**RE:** Indefinite Delivery of Fire Alarm Contracting Services  
Williams-Brice Nursing Building FA Upgrades  
(H27-D162-JM)

**ATTACHMENT:** Revised Specification Section 16750, page 13, paragraph 2.13. B.  
Added paragraph 2.7.D to Specification Section 16750, page, 11.  
Revised Drawing FA-10, Fire Alarm Riser Diagram

**1 FIRE ALARM RISER DIAGRAM**  
FA-9 NOT TO SCALE

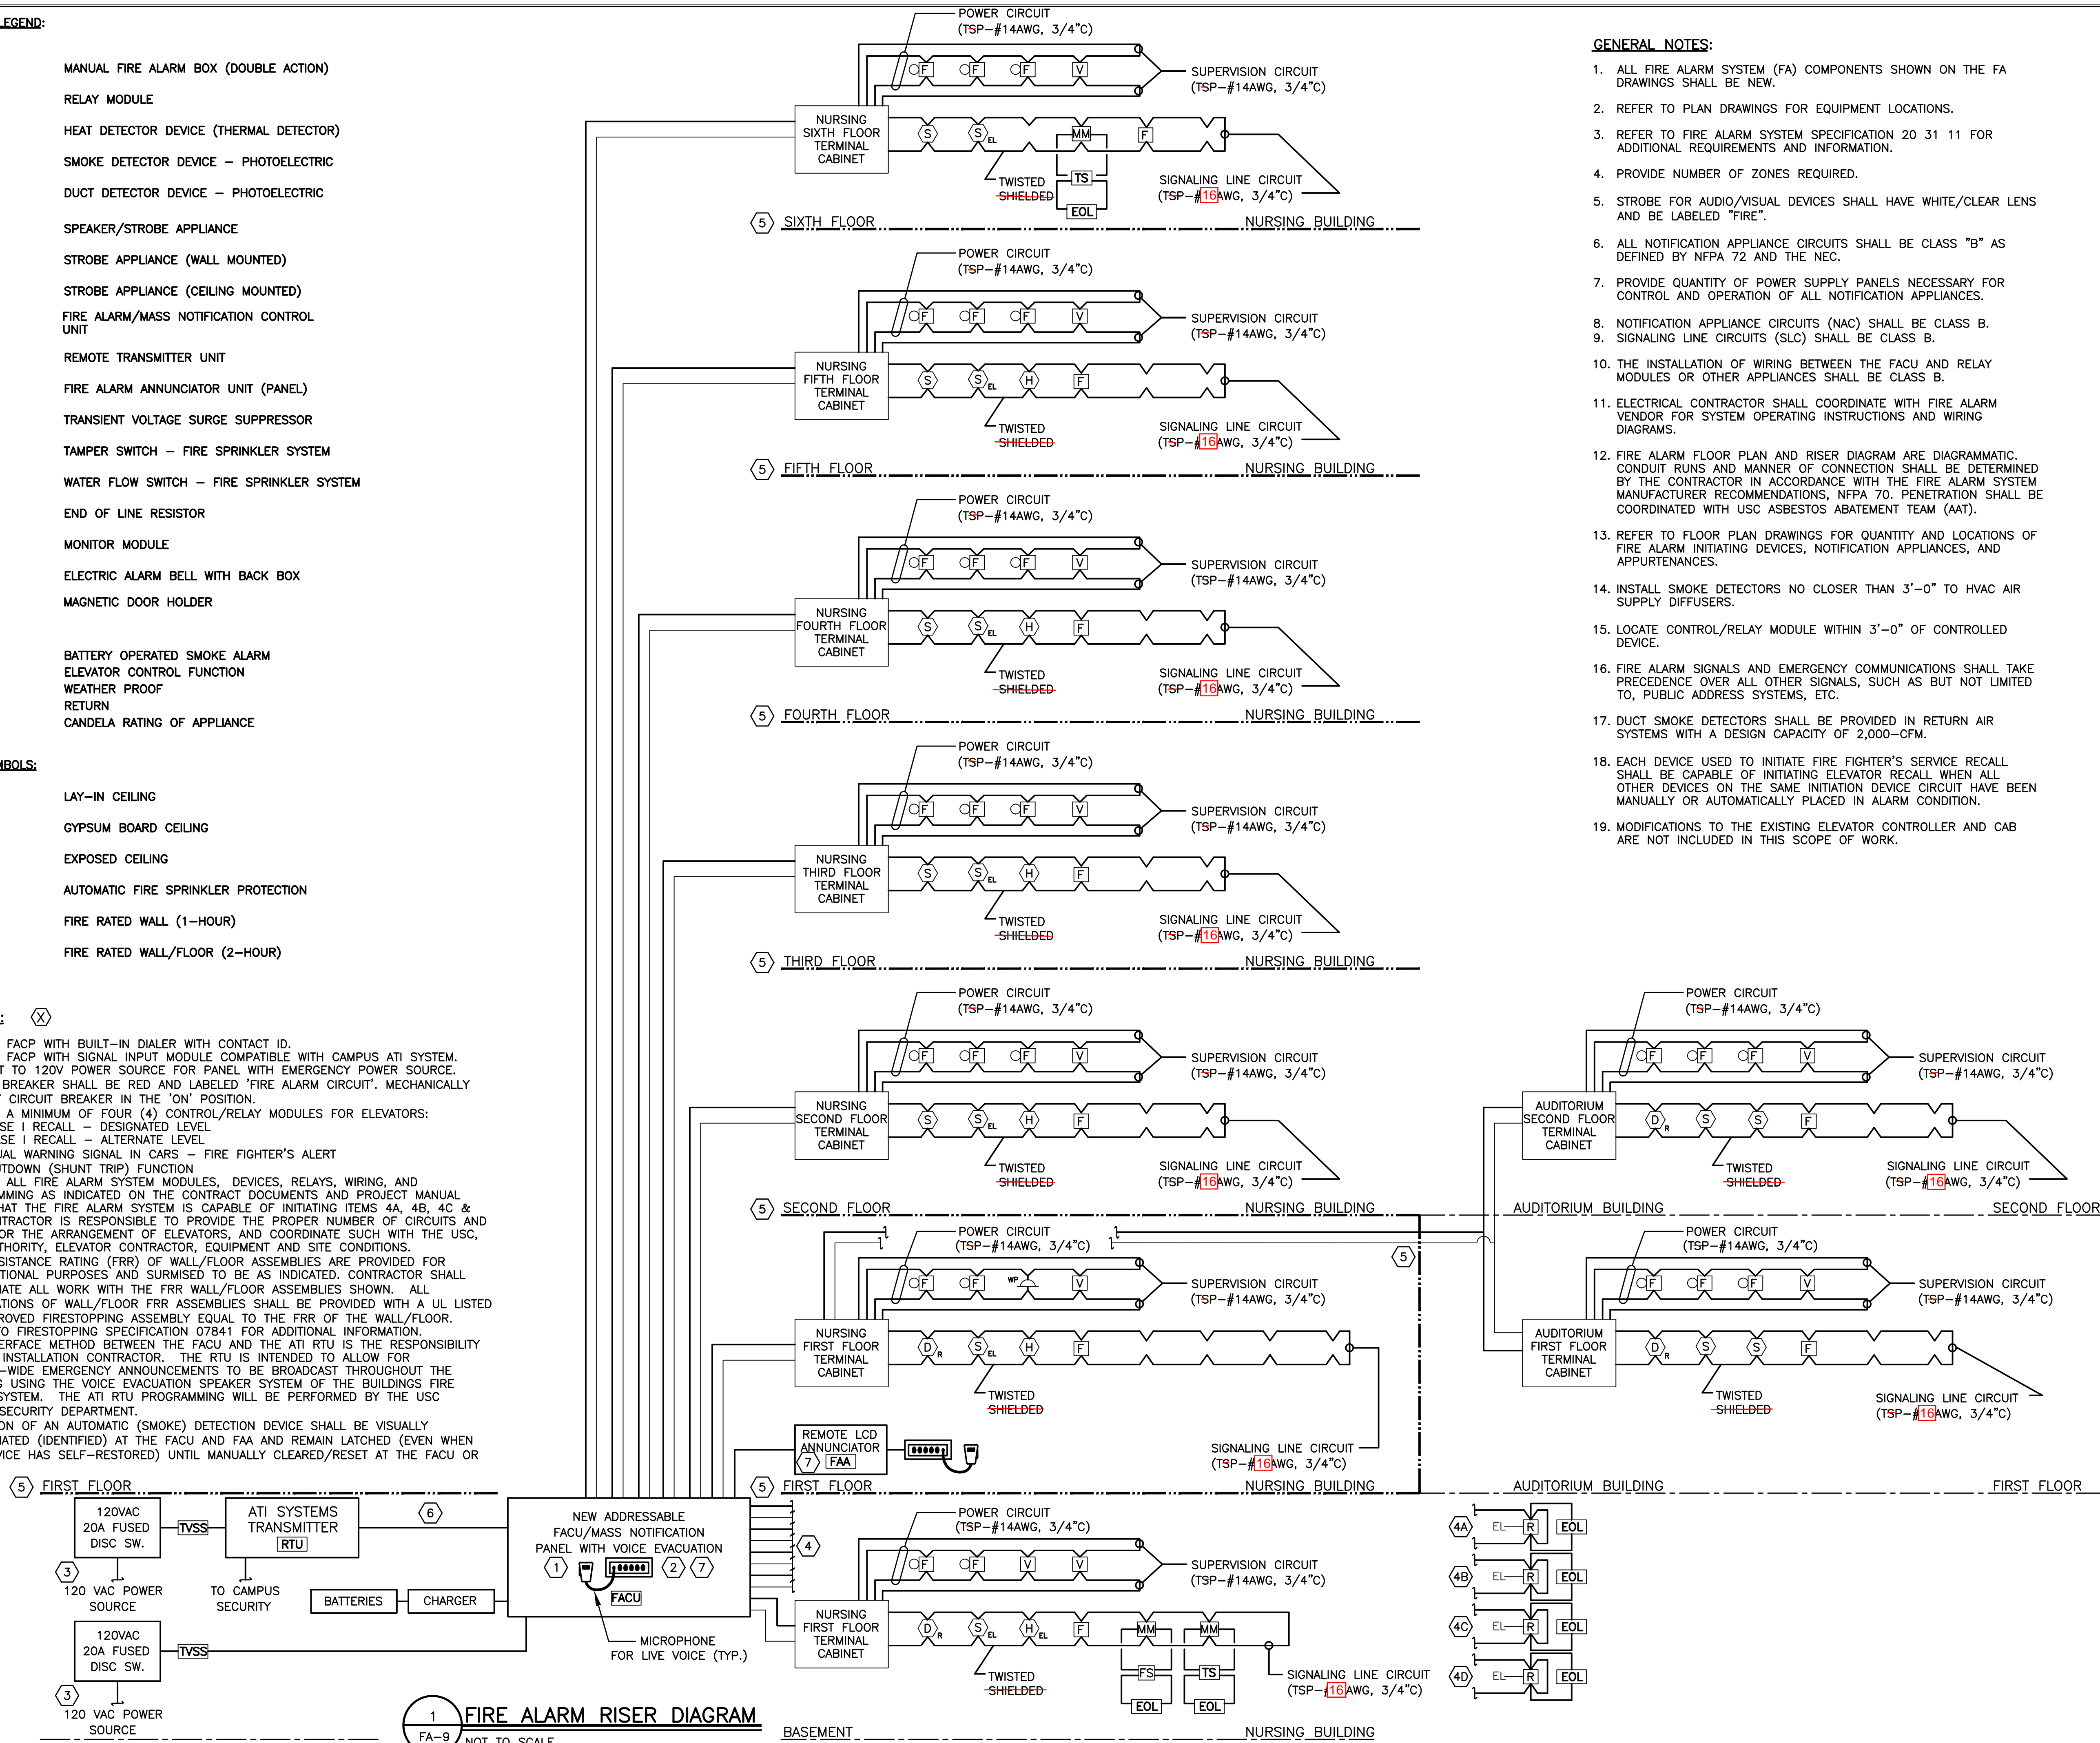
3. QUESTION: Are you requiring a microphone for the FAA?

4. QUESTION: What is the Electric Alarm Bell tied to?

RESPONSE: The purpose of the exterior electric alarm bell is for fire sprinkler system alarm and shall be connected to the fire alarm system. Paragraph 2.7.D, Electrically Operated Alarm Bell, has been added to the Specification 16750.

RESPONSE: Yes. Refer to sheet FA-10, Fire Alarm Riser Diagram.
